AIRWORTHINESS ADVICE NOTICE

TYPE AFFECTED: DG-400.

SUBJECT: Miscellaneous airworthiness information.

GFA AN 74	ISSUE: 8	11 June 2003	Page 2 of 4
-----------	----------	--------------	-------------

FIGURE 1 RELEASE CUT OUT

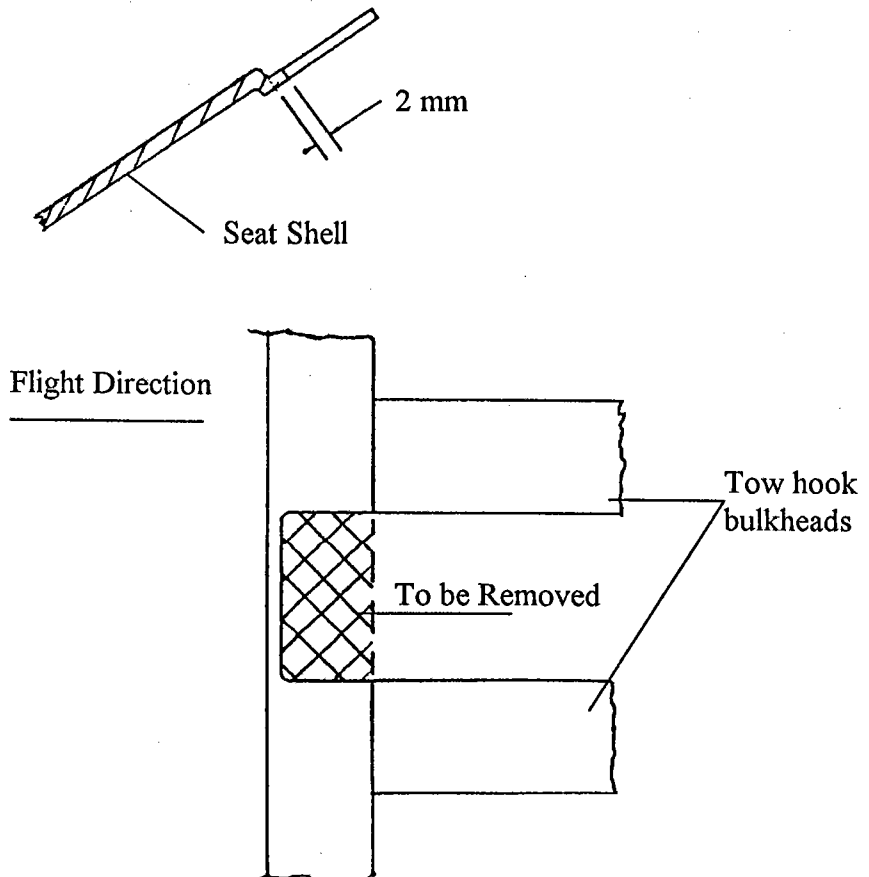
1. *SIMPLIFIED CG RELEASE REMOVAL.* The relatively small access hole for the belly release makes removal of the release at each annual inspection difficult. The cut out in the seat shell can be enlarged in accordance with Figure 1 to make removal of the release easier.
